DRB #2009-0001

**Carlyle/Eisenhower East Design Review Board
January 15, 2009**

REQUEST: Review of a revised design concept for the residential and commercial buildings.

LOCATION: 2250 and 2200 Mill Road (EESAP Blocks 19 and 20)

Figure 1. Design study of Block 20 form/envelope concept showing relocated wind turbine towers.

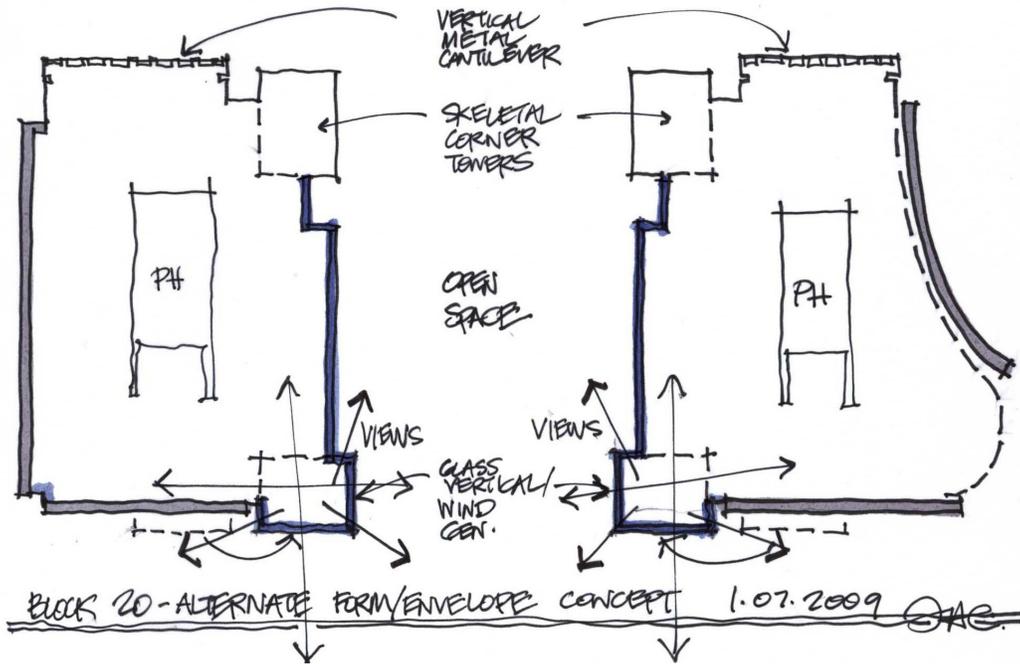
As the design of these vertical features has evolved from simple rectangular glass forms to more articulated forms incorporating a metal openwork crown with wind generators, their somewhat arbitrary location, centered on the south facades as add-ons, has seemed increasingly to conflict with the strongly asymmetrical approach that has been carried out so successfully in the rest of the design. As a way to resolve this, and simplify the expression of this important view, Staff is suggesting that Applicant study relocation of these towers to the inside corners of the central space (see plan diagram, below.) This could achieve several goals simultaneously: 1) make sense of the all-glass expression by defining it as an outgrowth of the interior glass skin that flanks the courtyard; 2) engage the towers with the central courtyard, while offering 270-degree views from the rooms within; 3) simplify the building expression facing the Beltway, so the towers have more visual impact; 4) make the exciting curtain wall interior more visible by wrapping it around the south façade; and 5) possibly achieve better airflow by moving these elements farther from the large rooftop penthouses. Staff also recommends some additional study to give the top forms associated with the wind turbines more visual impact, while understanding that air flow issues must be correctly addressed. See Figure 1 in Attachment B.
